Access Compliance Report Public Rights-of-Way (Curb Ramps)

Main Street: FAIRHAVEN_AVE Cross Street: MALENA_DR Location: SW

ADA ID: RPAT211021093743 Ramp Type: Type 1 - Perpendicular Initial Pass/Fail: Fail Overall Compliance: No Severity Score: 15

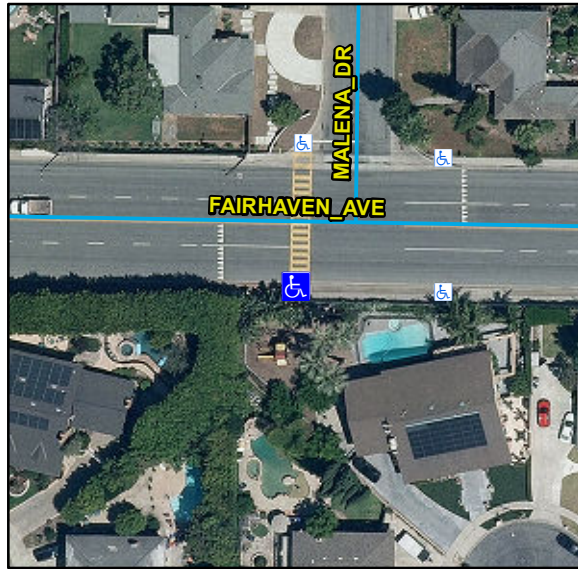
Compliance	Description	Data	Compliance	Description	Data
N/A	Ramp Length (in)	44	N/A	Flare Type LT	
Yes	Ramp Width (in)	55			N/A
No	Ramp Run Slope (%)	10.5	N/A	Flare Slope LT (%)	N/A
Yes	Ramp Cross Slope (%)	1.2	N/A	Flare Traversable LT	N/A
N/A	Landing Present	N/A	N/A	Flare Type RT	
N/A	Landing Length (in)	N/A			N/A
N/A	Landing Width (in)	N/A	N/A	Flare Slope RT (%)	N/A
N/A	Landing Run Slope (%)	N/A	N/A	Flare Traversable RT	N/A
N/A	Landing Cross Slope (%)	N/A	N/A	DWS Provided	N/A
N/A	Landing Movement Obstructed?	N/A	N/A	DWS Contrast	N/A
	Landing Movement Type	N/A	N/A	DWS Length (in)	N/A
N/A	Landing Shared	N/A	N/A	DWS Full Width	N/A
N/A	Clear Space	N/A	N/A	DWS Offset Left (in)	N/A
N/A	Clear Space To Crosswalk (in)	N/A	N/A	DWS Offset Right (in)	N/A
N/A	Marked Crosswalk 1	Yes	N/A	Marked Crosswalk 2	N/A
	Crossing 1 Direction	N		Crossing 2 Direction	N/A
	Marked Crosswalk 1 Width (in)	120		Marked Crosswalk 2 Width (in)	N/A

Remove & Replace Entire Ramp.

R304.2.2, STD 1115
